# CBD & South-East Light Rail Project Project SSI 6042

## Submission on CBD & South-East Light Rail Project

Submitted to NSW Department of Planning & Infrastructure  
On Behalf of University of NSW

16 December 2013 ■ 13533

Figure 32 – Current and Future Service Provisions – UNSW Anzac Parade Stop

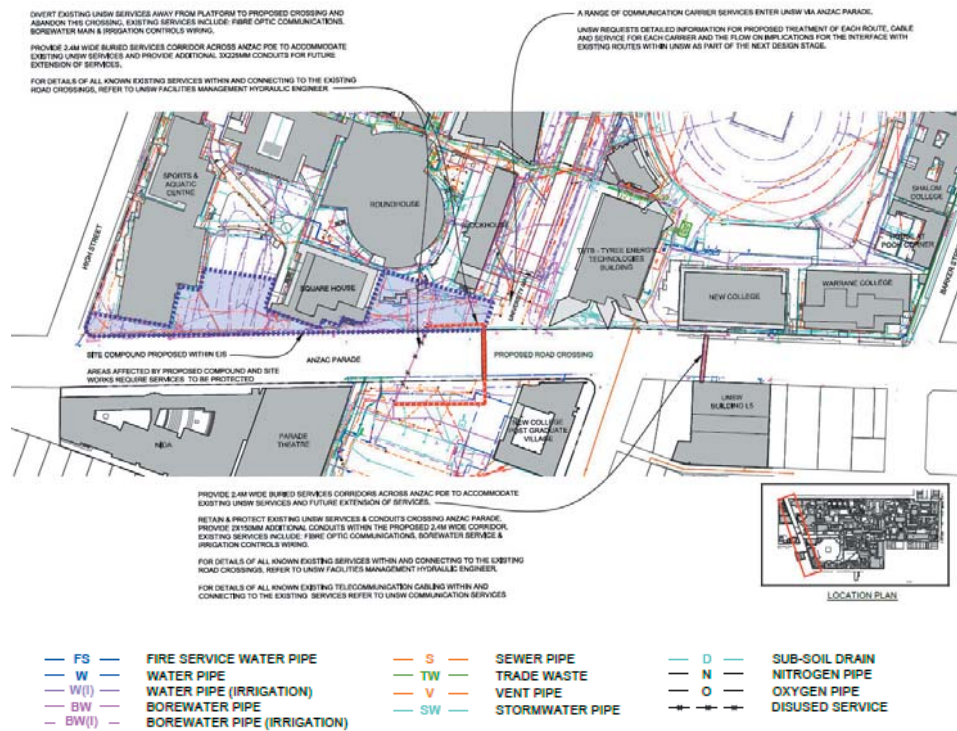
Currently, the EIS does not documentation does not include an existing conduit route across Anzac Parade to Western Campus on the relevant drawing. The conduit contains fibre and voice cables providing data & some voice services to National Institute of Dramatic Art and New College Postgraduate Village. It is the only route available and disruption will result in total loss of data service. It is therefore requested that the proposed treatment of this route is discussed in detail with UNSW Communications Services during the next stage of design.

Also, an area adjoining the south west corner of the UNSW Squarehouse building is included in the extent of the permanent works boundary. There are a communications services conduits running through the defined area. Routes included are the single lead-in voice and data route providing services to the Squarehouse as well as a cable route from Anzac Parade to the Blockhouse. It is requested that the proposed treatments in relation to these routes are discussed in detail with UNSW Communications Services and Facilities Management during the next stage of design.

UNSW plans to develop the Western side of Anzac Parade opposite UNSW Anzac Parade Station. UNSW Infrastructure and Utility services will be extended across Anzac Parade to further service that site. At least 6 x 300mm inside diameter PVC pipelines with at least 750mm cover to top of pipe are required.

Figure 33 – Current and Future Service Provisions – UNSW High Street Stop

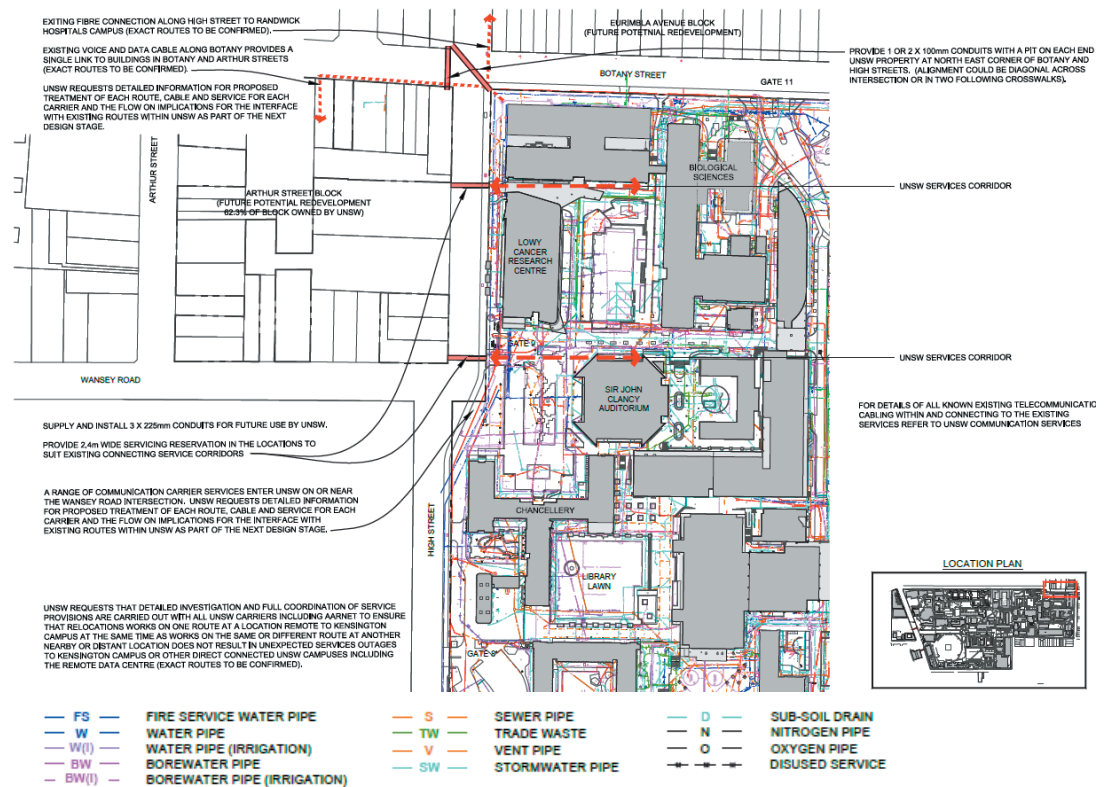
It is noted that an existing cable route running across High Street at Botany Street is not shown on the drawing. This conduit provides the route for voice and data cables to UNSW buildings in Botany Street and Arthur Streets. The route provides a single link to those premises. It is difficult to determine if another cable route running east along High Street providing fibre connection to various buildings within the POWH campus is included or not on the drawing.

There are planning proposals by UNSW to extend Kensington Upper Campus services north to service existing and new sites planned for purchase (Wansey, Arthur and Botany Streets). New conduits will be required to be installed N-S under High St to allow several water, borewater and gas mains to be installed. The
